Cranmer Avenue Snooker Centre Planning Appeal – Ref: 2125636

I write to you as Case Officer on behalf of Ealing Fields Residents' Association (EFRA) in respect of the above planning appeal.

Windings Place Building line set further back than the Edwardian housing

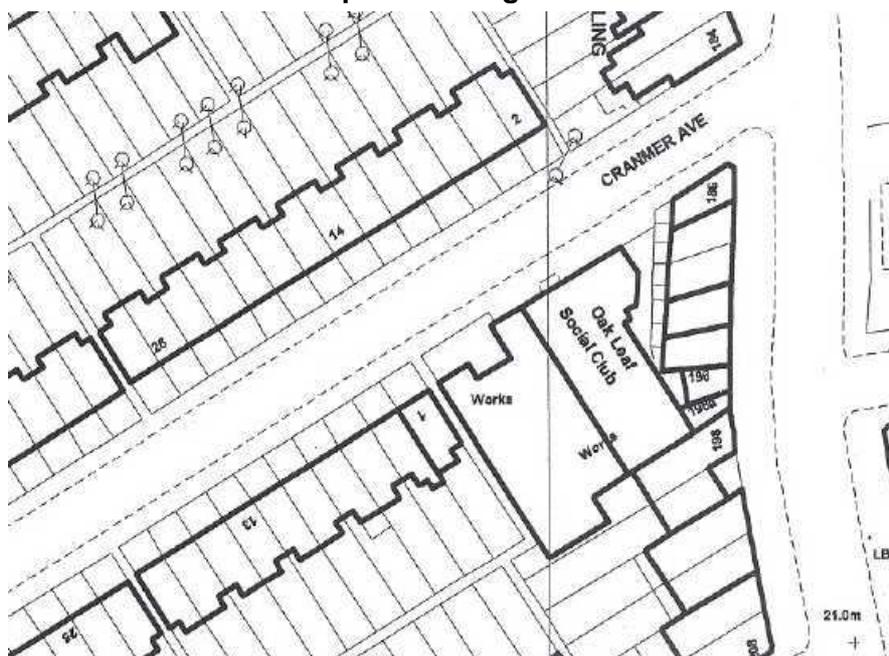
We believe that a number of the features of the Windings Place development provide a valuable example of the type of residential development which can be constructed on small non-residential sites, and which also complies with the Council's planning guidelines.

- Adopting a design which echoes that of the neighbouring Edwardian housing,
- Lowering of the roof ridge below that of the neighbouring housing,
- Retaining the roof ridge at the centre of the property, rather than moving the highest point forward to the pavement edge,
- Adopting a roof pitch at the front of the buildings which replicates that of the Edwardian terraced housing in the road,
- The absence of dormers in the front roof,
- Setting back the building line from that of the former building,
- Provision of a rear garden for each property,
- Provision of off-street parking.

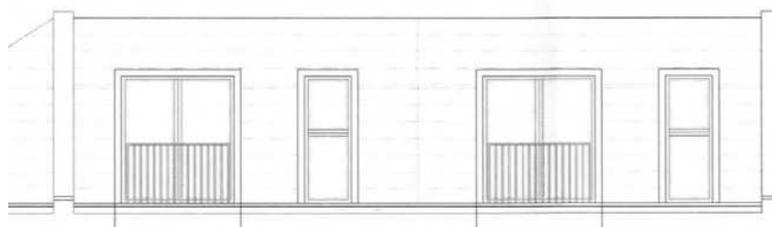
A comparison of the existing and proposed ground floor plans contained in the Design and Access Statement shows that the window bays will project forward onto the paved area in front of the current building.

A review of the proposed elevations and upper floor plans show these bays rising upwards to the level of the eaves of the second floor mansard. The nature of these bays is substantial and cannot be compared to the visual impact of a ground floor entrance porch.

We regard the construction of these projecting bays as unacceptable.

Front Elevation

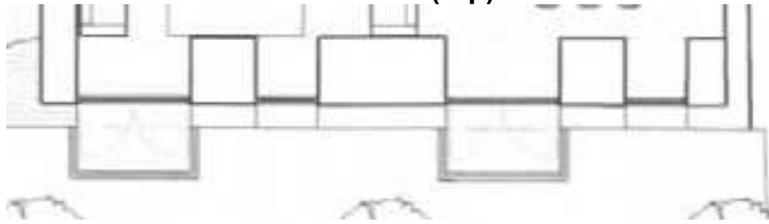
We draw your attention to the proposal to construct balconies in the steep mansard storey facing Cranmer Avenue. Extracts from the Design and Access Statement are shown below.

This proposal appears to be in breach of UDP Table 5C,3 which states,

“Roof terraces and balconies will not be permitted where they overlook neighbouring habitable rooms or garden space.”

It also appears to be in breach of the following statement on page 20 of SPD 4, which states:

“Balconies associated with roof extensions and dormer windows are not encouraged, due to the potential for overlooking neighbouring properties and because of their visual impact.”

For these reasons we believe that the inclusion of balconies should be refused.

3.5 Side Elevation

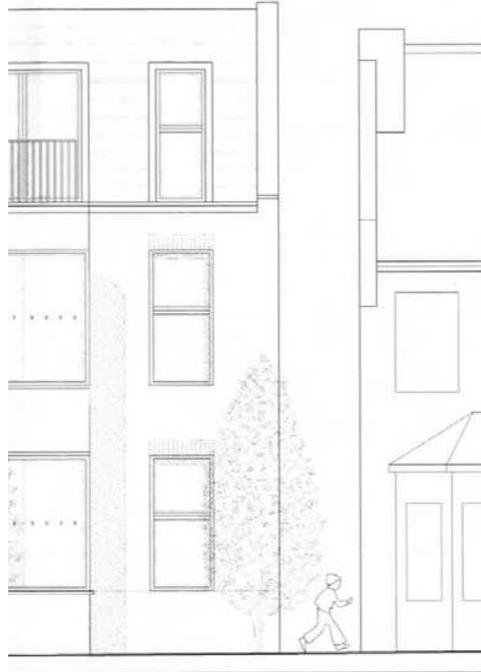
The gently sloping, west facing, roof of the projecting portion of the snooker hall serves to minimise the visual dominance of this structure.

The height of the western side wall of the replacement three storey building will be approximately double that of the white side wall of the snooker hall. It will therefore visually dominate the whole street, in addition to overshadowing the front of Windings Place.

**Extract from Planning Application Statement
Example of Forecourt/Pavement Parking**

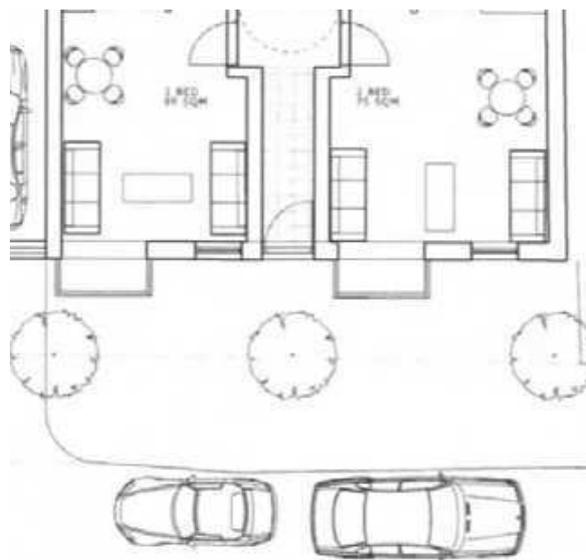
The Design and Access statement fails to address the treatment of the pavement area in front of the two ground floor flats. Page 4 of the Planning Application Statement shows a car parked in this location.

We therefore suggest that the developer be required to hard landscape this area, with the inclusion of brick planters, in order to prevent off-road parking and to protect the privacy of the residents of the ground floor flats.

4.2 Second Floor Layout

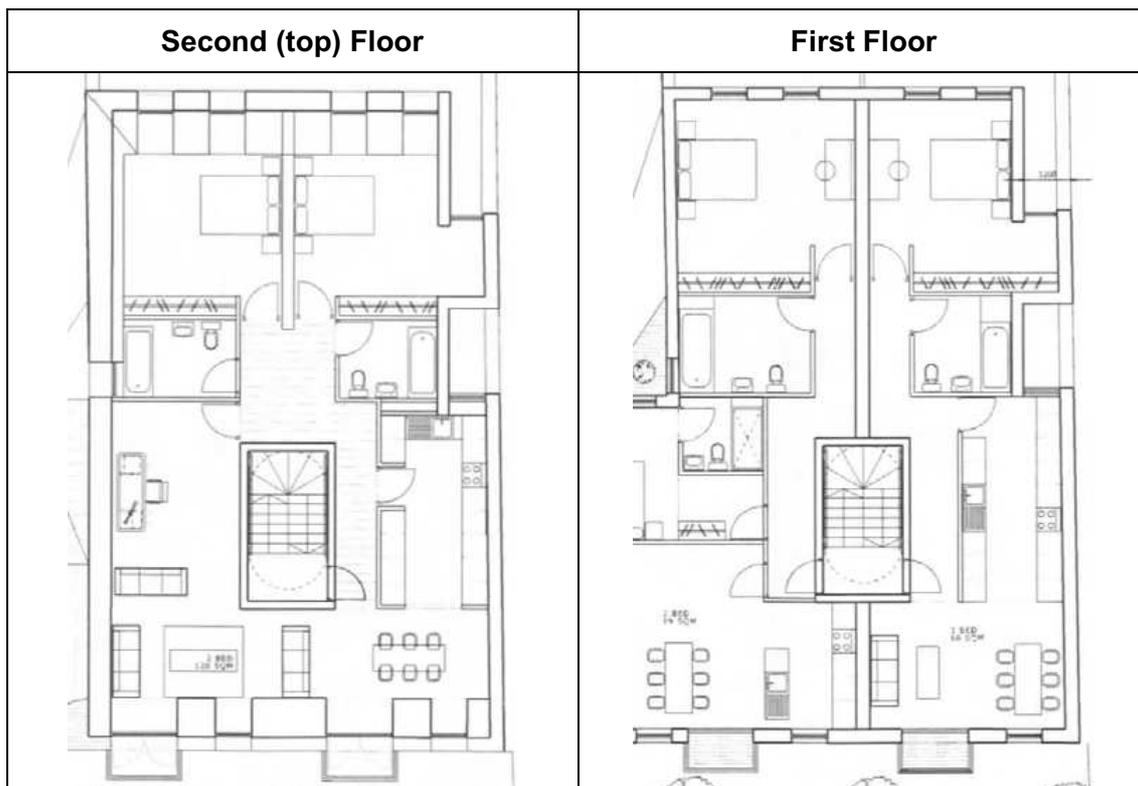
We are particularly concerned at the symmetrical internal layout of the proposed second floor and the ease with which it could be converted to two single bedroom flats. The layout of the first floor single bedroom flat, on the eastern side of the proposed building, is virtually identical to either side of the proposed second floor. Extracts from the Design and Access Statement which demonstrate this coincidence are shown below.

We therefore request that if the current version of the application was to be approved, it should be accompanied by a planning condition that would prevent any future reconfiguration of the second floor, and that the condition should be incorporated into the lease for the second floor flat.
